Groundwater Application Review Summary Form

Application # G- 18932

GW Reviewer Phillip I. Marcy Date Review Completed: 5/6/2020

PUBLIC INTEREST REVIEW FOR GROUNDWATER APPLICATIONS

Water-Level Trends in Nearby Wells

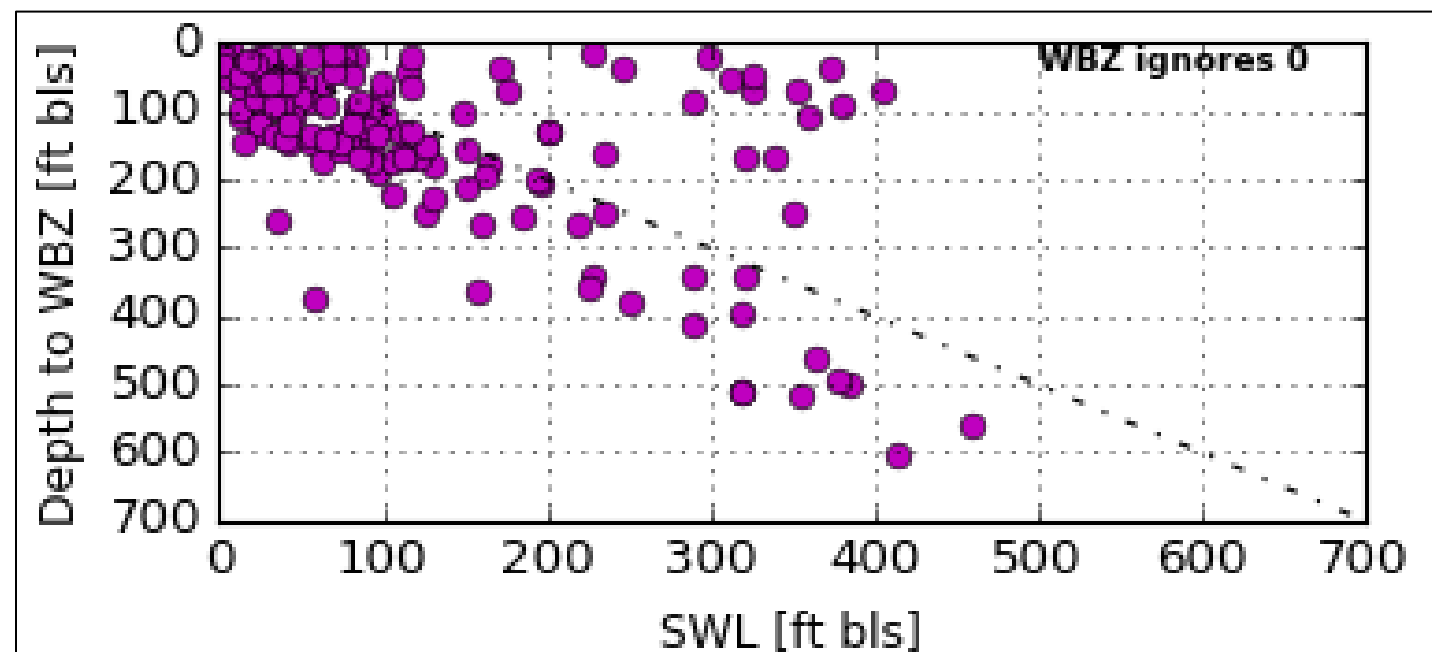
Groundwater elevations vary widely in the area near the proposed POA, largely controlled by the elevation from which groundwater is produced. One exception is CLAC 13589 (red), which is cased to 75' AMSL at a depth of 575' BLS, with resulting groundwater elevations from 220' to 230' AMSL.

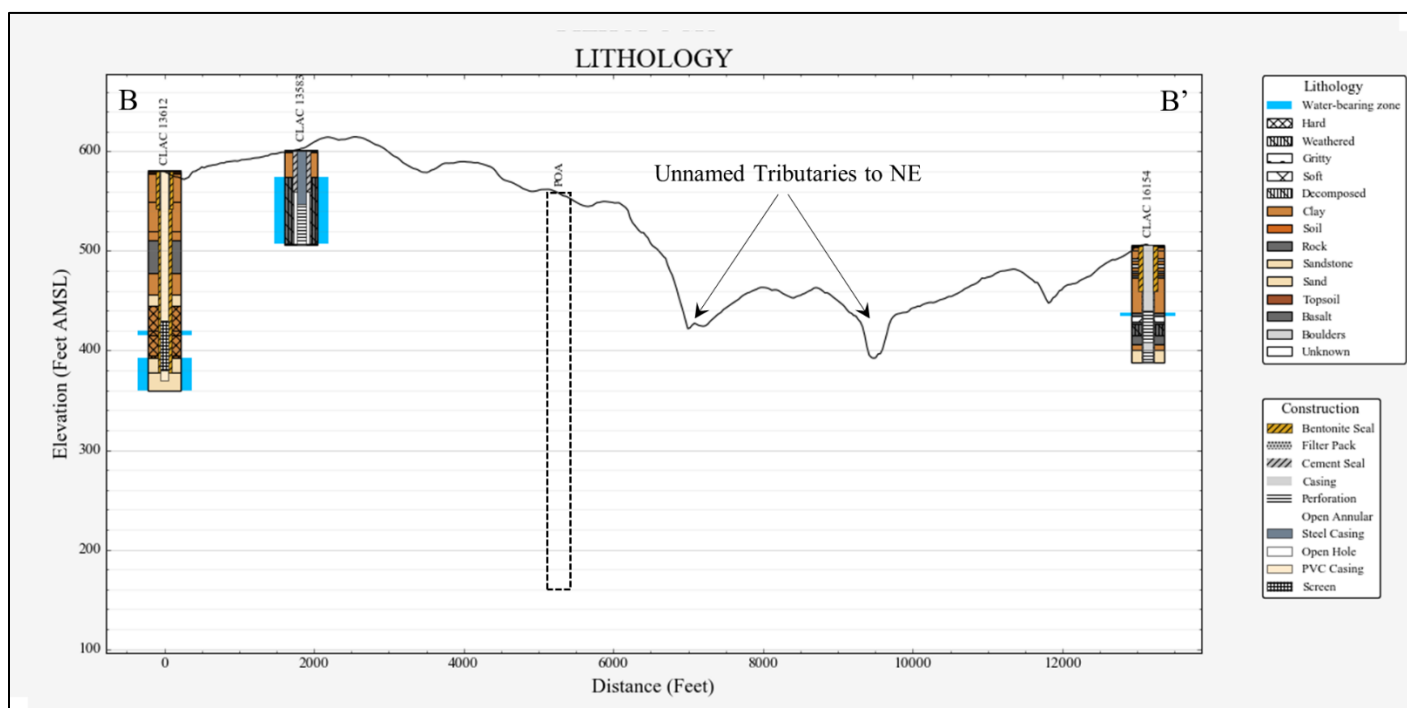
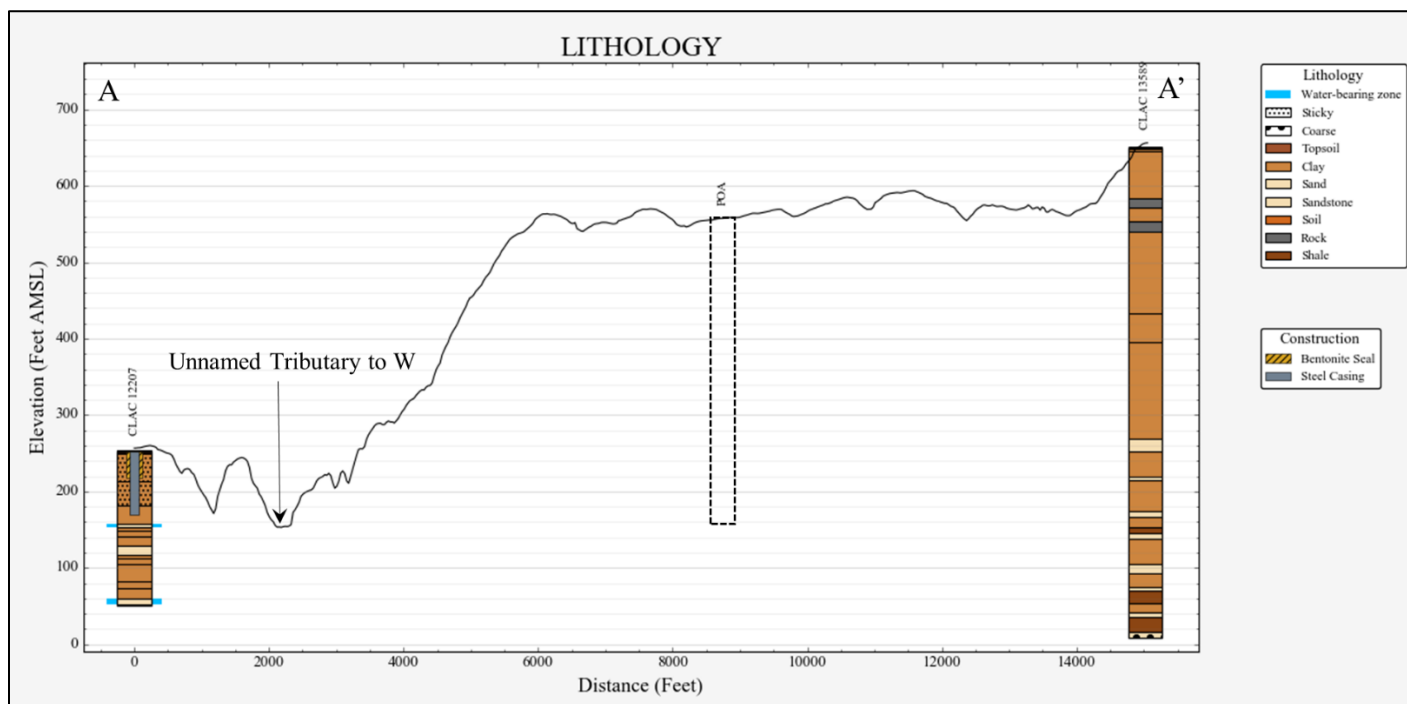
Statistics from the section of the proposed POA, in addition to surrounding sections suggest that while some degree of confinement exists in water-bearing zones accessed by local wells, head generally declines with increasing depth. There also exist a significant minority of wells where head is below the zone from which water is produced.
